CITY OF OLYMPIA
Olympia Design Review Board

CONCEPT DESIGN REVIEW
STAFF REPORT
May 15, 2014

Case: Tanasse Mixed Use Building, 14-0025

Request: Conceptual Design Review

Figure 2 Subject Site and Surrounding Zoning. CPD, 2014.

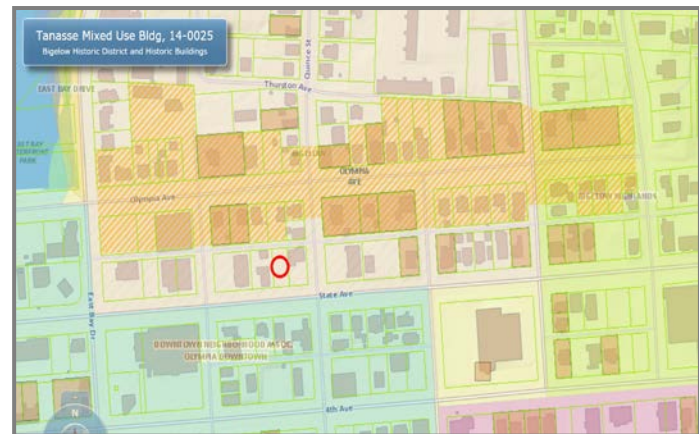
- ↑ **North of the Site** – Olympia Avenue Historic District (Figure 2).
